PCN # ESW490-44 – Thyristor & Diode TO247_ISO247_PLUS247_ISOPLUS247 Packaging Location Transfer

Product/Process Change Notice (PCN)

PCN#: ESW490-44 **Date:** June 28th, 2022

Thyristor & Diode
TO247_ISO247_PLUS247_ISOPLUS247
Package Products

SBU - LIPA TUBE LABEL

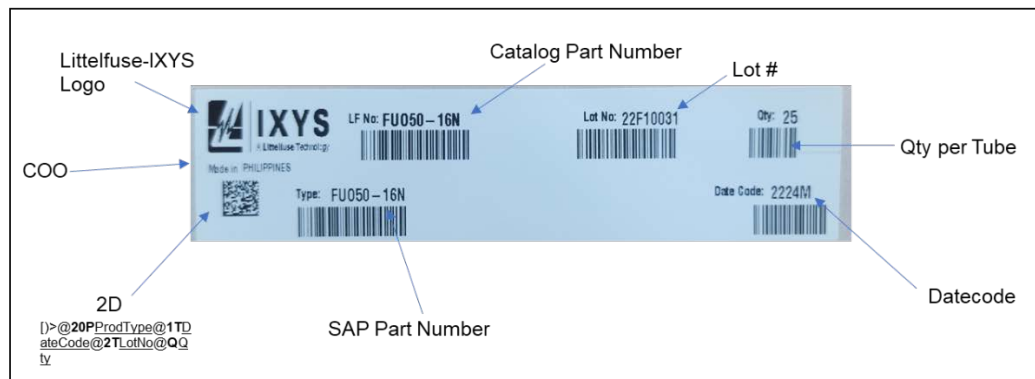
- 1) **Silicon Die:** No change
- 2) **Backend Assembly Bill of Materials:** No change
- 3) **Backend Assembly Process Flow:** No change
- 4) **Backend Assembly Equipment:** Equal or better
- 5) **Marking & Labeling:** Yes. Changes pls refer to below details.

DESCRIPTION	EXISTING LOCATION	SBU-LIPA	CHANGE (Y/N)	RISK	REMARKS
Unit Marking					
Logo			Y	LOW	Change to Littelfuse Logo
UL Sign	Yes	Yes	N	NR	No change
Trademark Sign	Yes	Yes	N	NR	No change
Product Name	Yes	Yes	N	NR	No change
Date Code	YYWW	YYWW	N	NR	No change
Assembly Line Code	L	M	Y	LOW	Site location code
Lot ID	FKT #	Lipa Lot ID format	Y	NR	SBU-Lipa uses global format
Box Label					
RoHS Label	e1 	e3 	Y	LOW	Both have printed RoHS compliance label
Logo			Y	NR	Change to Littelfuse Logo
Qty per Box	Yes	Yes	N	NR	No change
Part Number	Yes	Yes	N	NR	No change
Lot No	No	Yes	Y	LOW	Additional information from SBU-Lipa
Country of Origin	Yes	Yes	N	NR	No change
Code Type	Barcode	Barcode + 2D Code	Y	LOW	Additional scanning code to access information
Lot ID	FKT #	Lipa Lot ID format	Y	NR	SBU-Lipa uses global format
Date Code	Yes	Yes	N	NR	No change
Assy Line Code	L	M	Y	LOW	Site location code
Tube Label					
Logo			Y	NR	Change to Littelfuse Logo

Qty per tube	Yes	Yes	N	NR	No change
Part Number	Yes	Yes	N	NR	No change
Lot No	No	Yes	Y	LOW	Additional information from SBU-Lipa
Country of Origin	Yes	Yes	N	NR	No change
Code Type	Barcode	Barcode + 2D Code	Y	LOW	Additional scanning code to access information
Lot ID	FKT #	Lipa Lot ID format	Y	NR	SBU-Lipa uses global format
Date Code	Yes	Yes	N	NR	No change
Assy Line Code	L	M	Y	LOW	Site location code
